Brocade Fabric OS v5.0.5b

Release Notes v1.0

November 03, 2006

Figure 14-1 Accessing Performance Graphs

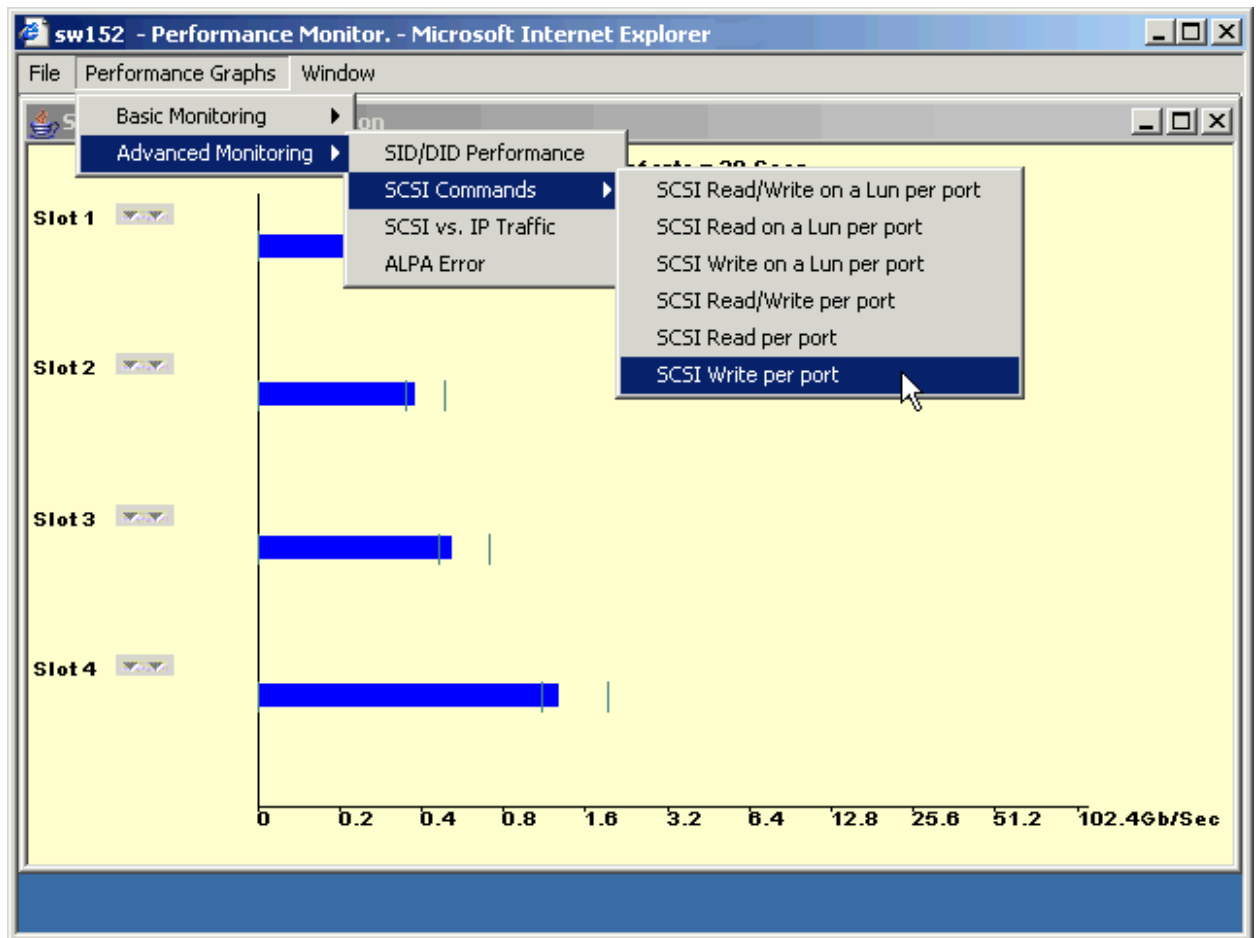
On page 14-3, replace Figure 14-1 with this one:
